# Planning Board Meeting Minutes

## April 14, 2022

Re: RPNY Solar 4, LLC Planned Development District (PDD) Application  
Review of 3/24/22 Submittal Package  
File No. 331.014

## SITE PLAN

C005

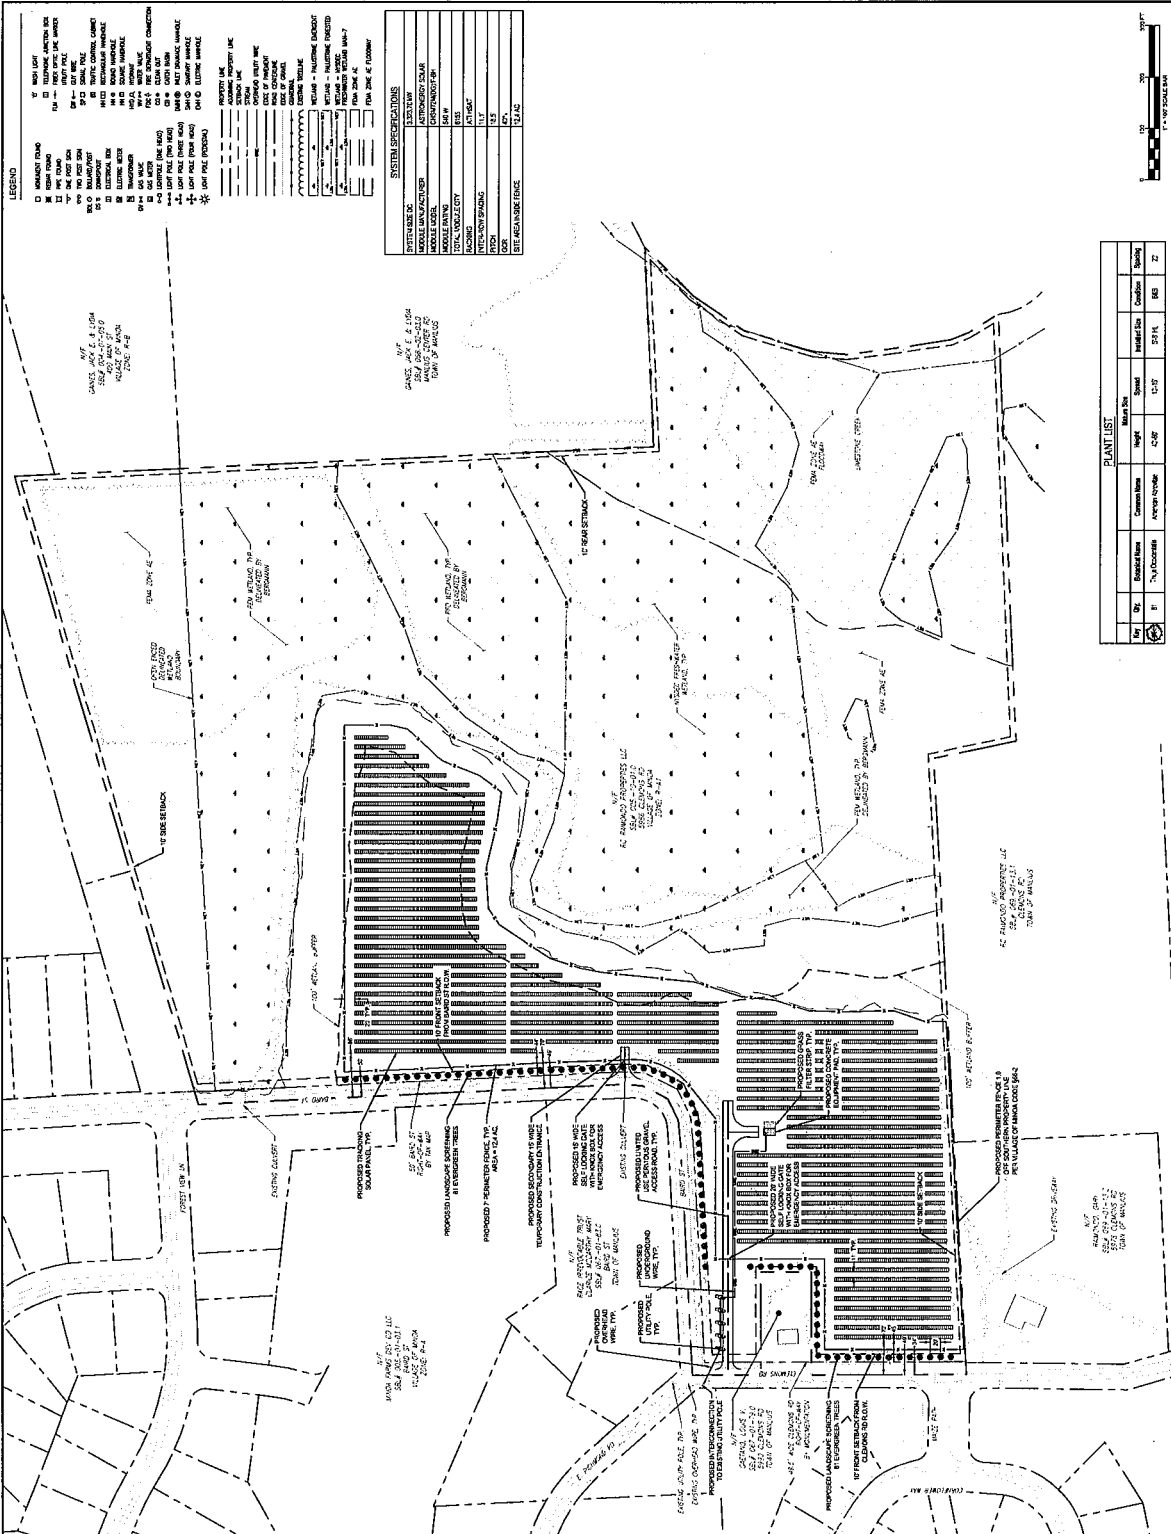
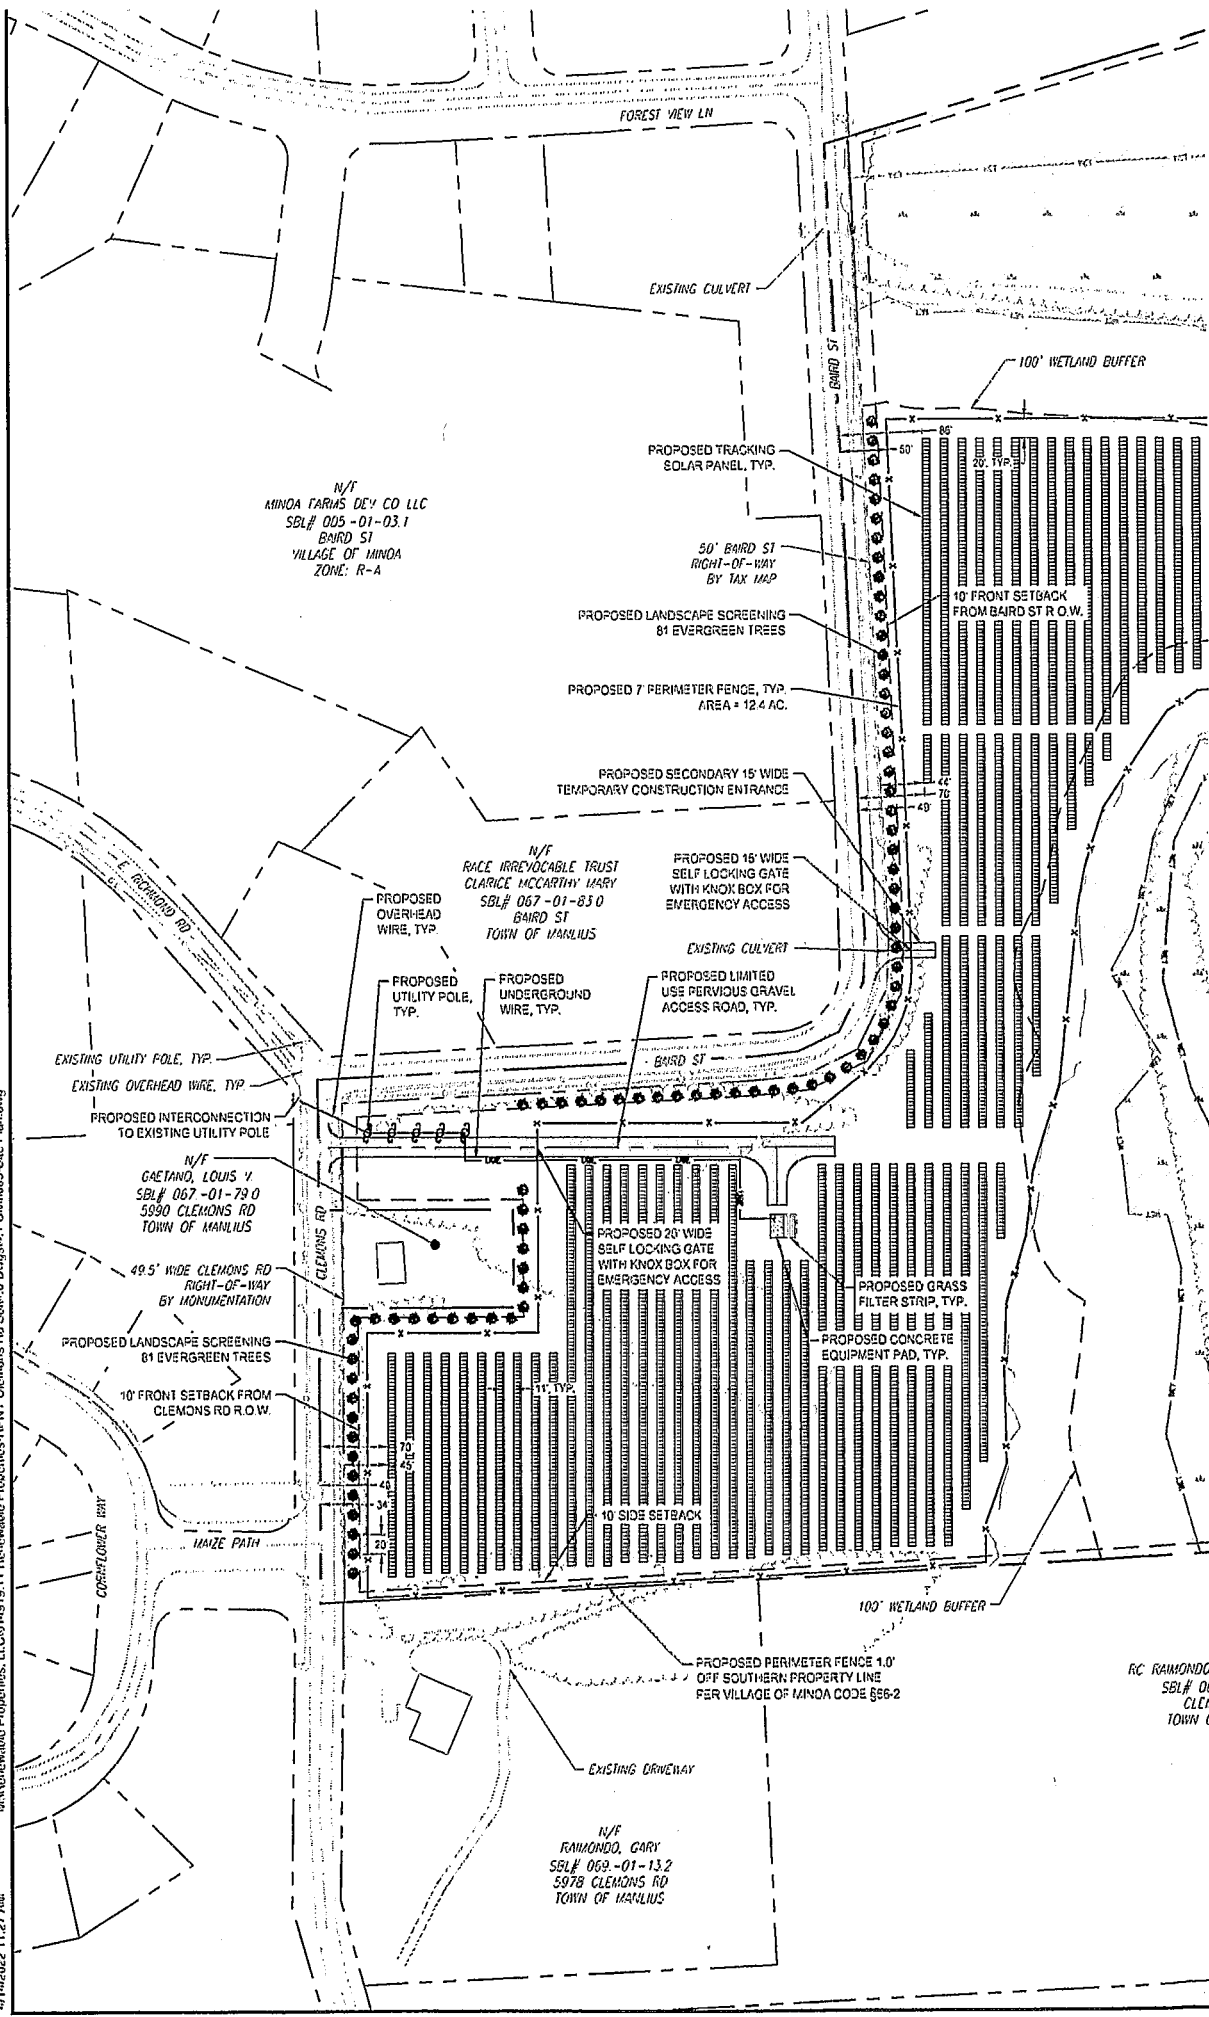
- Chairman DeLucia stated he would like clarification on setbacks from what was previously presented and the comments in Village Engineer letter.
- Mark Potter stated that they did not previously have definitive proof of the exact location of the right-of-way, RPNY Engineer wants to see if he can get confirmation from village that the dimensions shown on the site plan are correct. Attorney Hills advised that their Engineer needs to pull Deeds to get Legal Descriptions of properties. Mr. Potter stated their Engineer is aware he needs to obtain Legal Description and an updated Survey.

- Alan Archer stated Deeds in Village usually go to center of road.
- Mark Potter stated the first panel on the presented Site Plan is 45 feet from right-of-way

- Mark Potter stated the Village Engineering request of 100 feet RPNY would requiring losings 2 rows of panels and reduce megawatts to the point where the project would not be feasible.

- Mark Potter clarified for Board that the trees would be after the roadside ditch on right-of-way line, then the distance from trees to the fencing would be 20 feet, from fence to the first panel would be an additional 20 feet, thus giving 45 approximate feet from right-of-away. The members agreed that a 45 ft. from right-of-way as presented on current site plan was acceptable.

In my 3/3/22 letter, I suggest that the Village and applicant reconsider the setbacks proposed by the applicant. Most importantly, I recommended a larger front yard setback to allow for adequate visual buffering. The current plans submitted by the applicant suggest a 10 feet front yard setback from the centerline of Baird Street and Clemons Road. This setback would fall within the limits of pavement of both roads. I don't believe this is the applicant's intent nor would it be acceptable to the Village as it would not accommodate any visual buffering.

The current plans show the nearest solar panels approximately 70 feet from the road centerline (or approximately 45 feet from the r.o.w. boundary). I'm confused why the applicant requests a front setback of 10 feet when their plans show a 45 feet front setback. In my previous letter, I suggested a front setback of 100 feet (from the r.o.w. boundary). As a minimum, I recommend the required front yard setback be increased to be consistent with the 45 feet setback used on the current plans. I also again recommend that the applicant provide photo simulations of the project to help the Village evaluate the requested setbacks.
